PCN – Product Change Notification

Document No PCN-A-1100908 **Revision** 1.0

PCN Topic: Update 7 inches Open Frame Drawing_W07T700-OFA2

Old Mechanical Design:

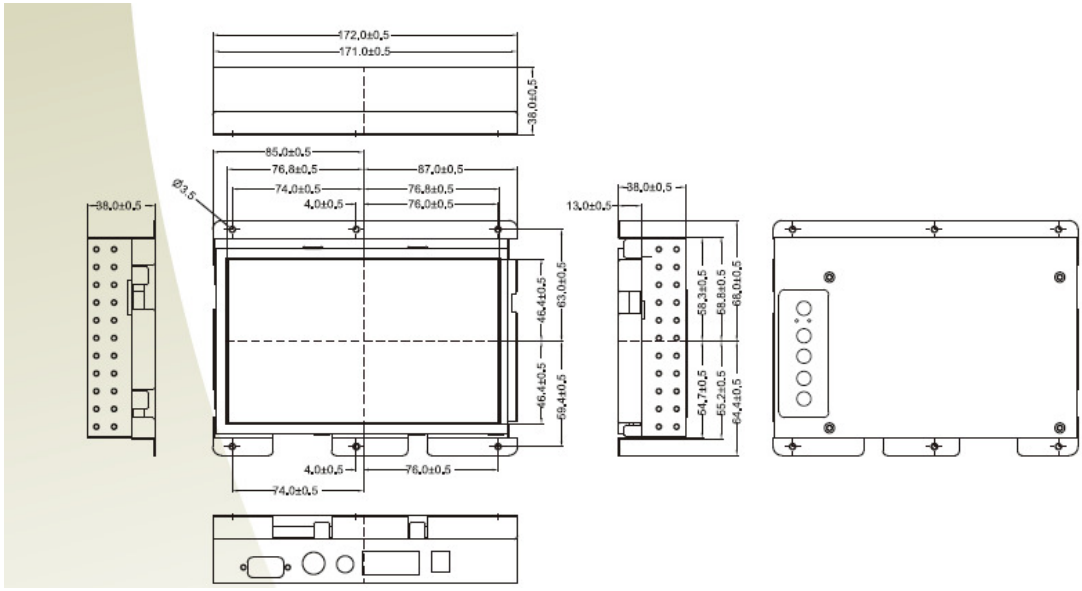
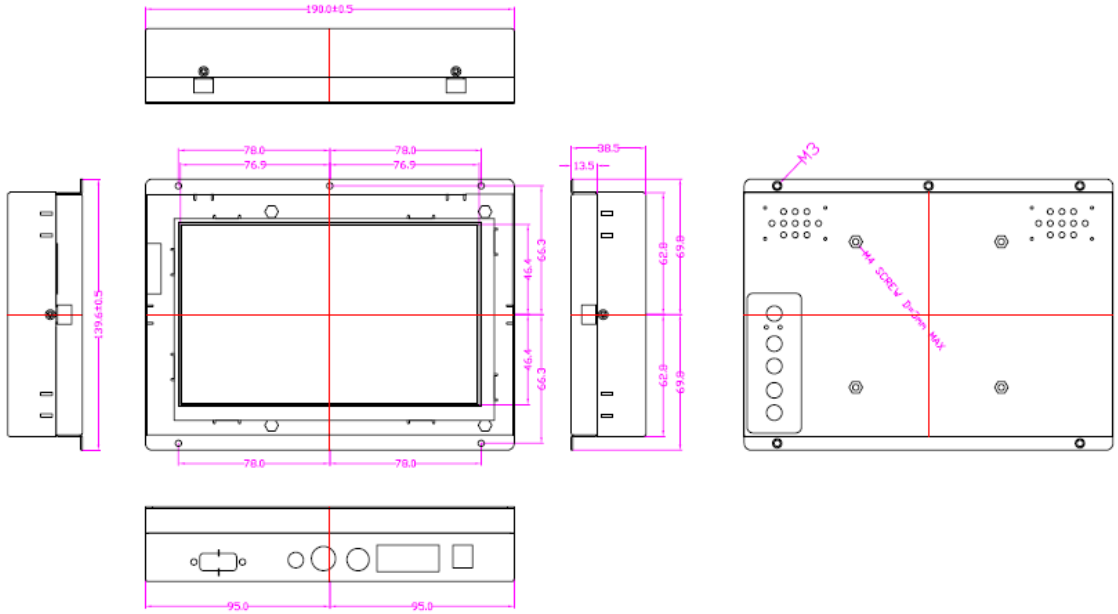
Due to the change of mechanical housing, we would like to inform you that about our product changes on the product drawing.

We will release new 7 inches Open Frame LCD drawing for the model of W07T700-OFA2:

The dimension of this model will be change from 172*132.4*38 (W*L*D) to 190*138*38.5.

The below pictures show the example of how the new drawing differ from the original one.
